READING GOLF CLUB, READING BERKSHIRE

DESIGN AND ACCESS STATEMENT - LANDSCAPE CHAPTER
MAY 2021 ADDENDUM REVISED VERSION

OFFICERS COMMENTS AND RESPONSE

FIGURE 3.4A – TREE RETENTION, REMOVAL AND PROPOSALS PLAN (ARBORTRACK SYSTEMS LTD & FABRIK, DECEMBER 2020)

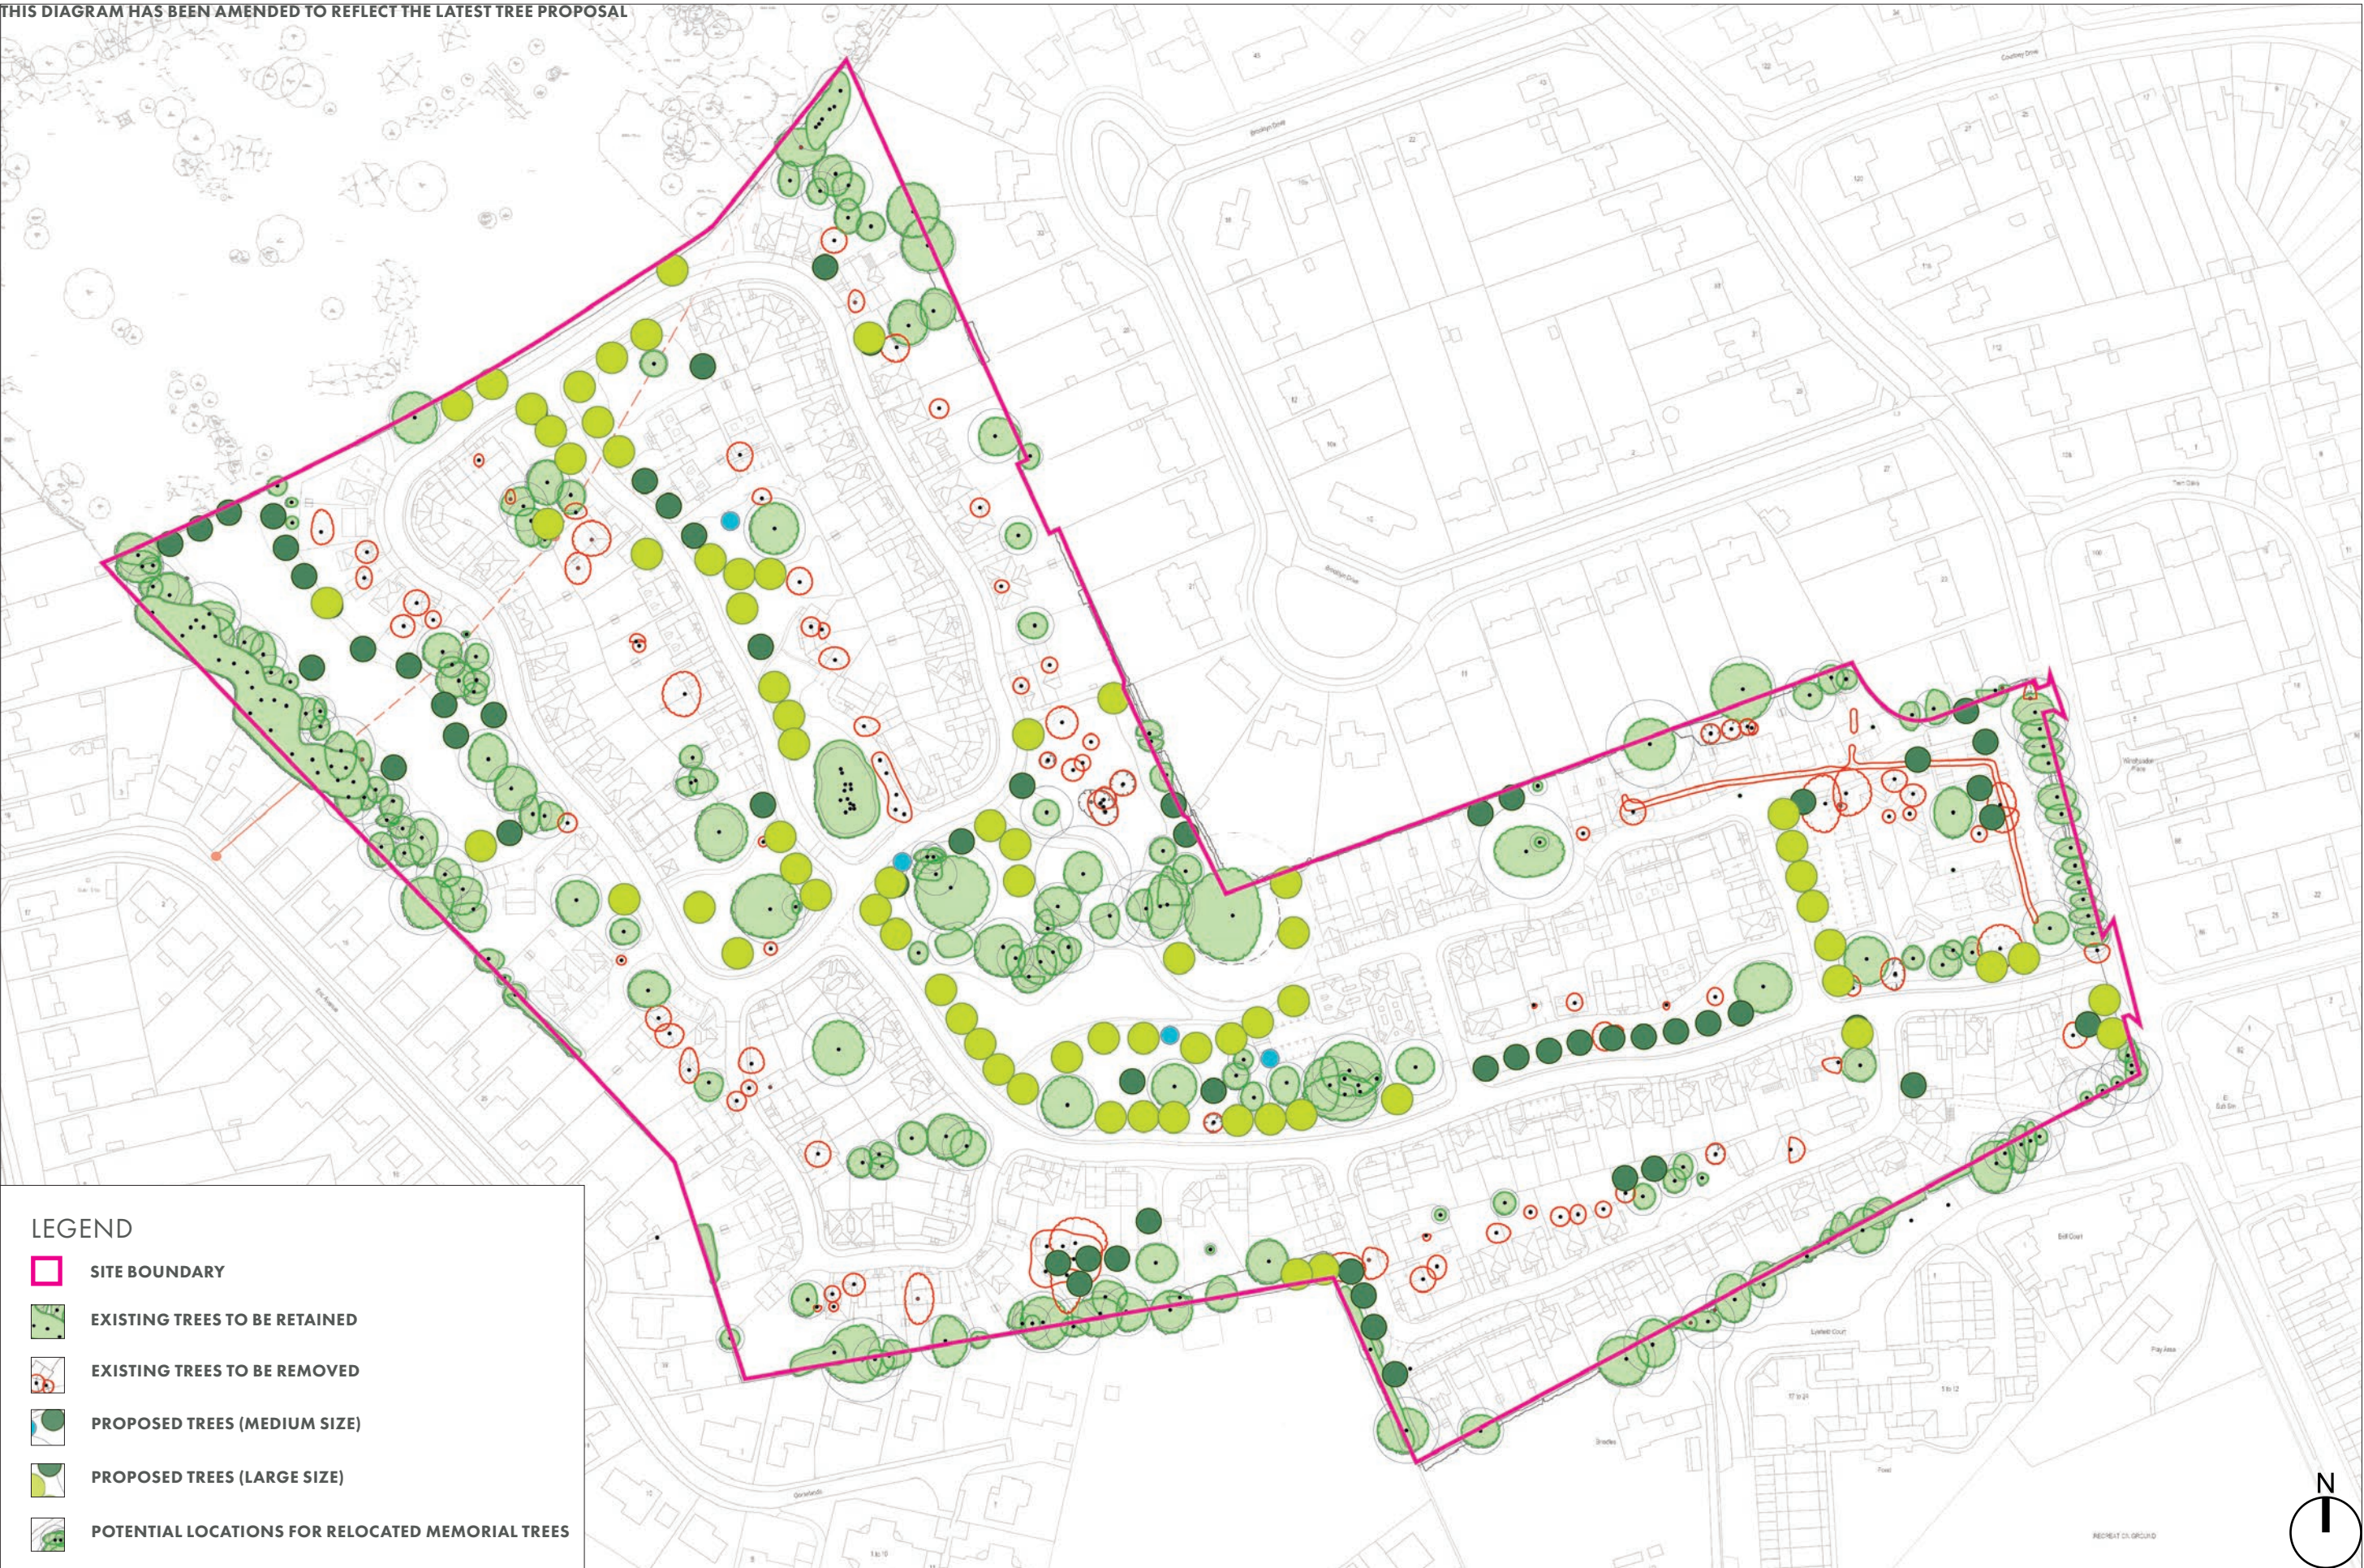
Clearly this development will be liable to CIL contributions, but not including a MUGA (and possibly no LEAP) will therefore attract S106 funding in addition to CIL.	Noted and it was agreed during the pre-app process that contributions would be made regarding the provision of a MUGA.
DATED 11TH MARCH 2021 REGARDING OPEN SPACE	
The planting notes are generally acceptable although the British Standards referred to are outdated. BS4034:1989 has been withdrawn and BS3882 should be 2015 not 2007; It is appropriate no to refer to BS8545:2014 ‘Trees: from nursery to independence in the landscape. Recommendations’; Biosecurity statement should be provided in relation to the suppliers to be used.	This has been addressed in the revised drawing D2743 Reading Golf Club L_103 Tree Plan revision 11.
It is noted that the majority minimise potential conflicts (subsidence) with new dwellings, however there are a few locations where this is not avoid hence, as with existing trees, foundation type will need careful consideration.	This has been reviewed and addressed in the revised drawing D2743 Reading Golf Club L_103 Tree Plan revision 11, in relation to trees opposite to plot 121-130, south of plot 130 and the east of plot 162.

It should be noted that the tree number to be removed stated is not consistent with the Arb document.	This has been addressed in this revised DAS.

Refer to Figure 3.4A - Tree retention, removal and proposal plan. *Figure 3.4B shows the latest tree retention, removal and proposals following the Tree Officer’s comments dated the 11th March 2021.*

THIS DIAGRAM HAS BEEN AMENDED TO REFLECT THE LATEST TREE PROPOSAL
